MEMORANDUM

TO: PLANNING COMMISSION
FROM: KEN ONDICH – PLANNING / COMMUNITY DEVELOPMENT DIRECTOR
KYRA CHAPMAN - PLANNER
SUBJECT: REQUEST FOR CONDITIONAL USE PERMIT #C1-2025 TO ALLOW
EXTERIOR STORAGE, LOCATED AT 605 6TH STREET NW IN THE I1-
LIGHT INDUSTRIAL ZONING DISTRICT, AS PROPOSED BY BEVCOMM.
DATE: 3/26/25

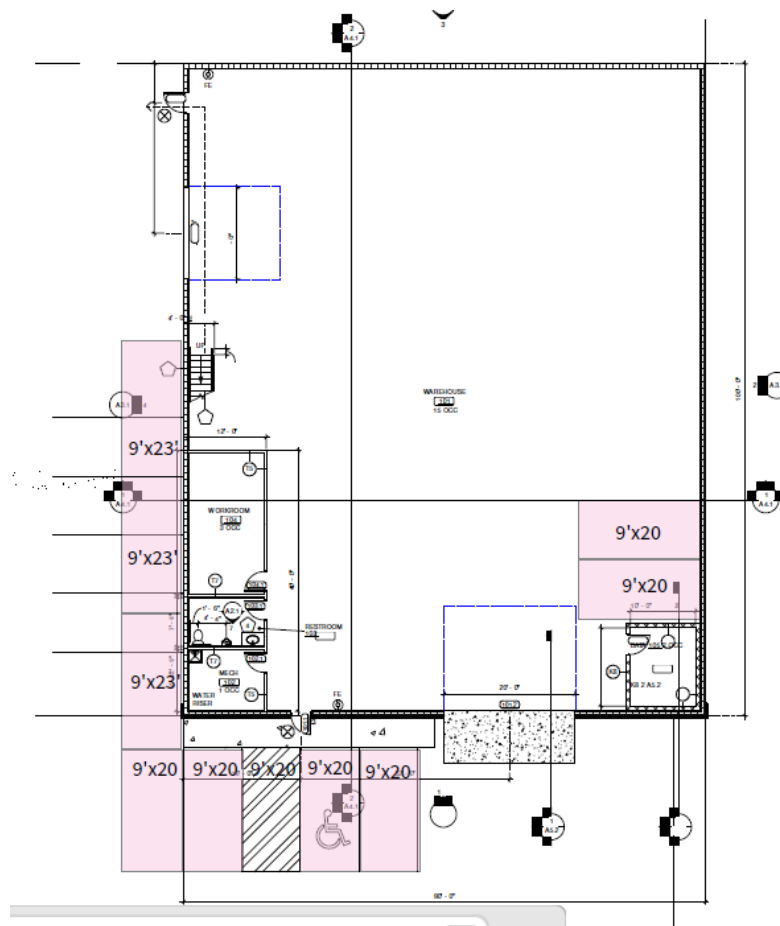
There will be about 239 sq ft of office space and 7,748 sq ft of warehousing space. That means a minimum of 9 parking spaces are required (8 spaces for warehousing use and 1 space for the office use). There are currently 7 parking spaces striped on the site on the exterior and 2 on the inside of the building which would meet the minimum requirements.
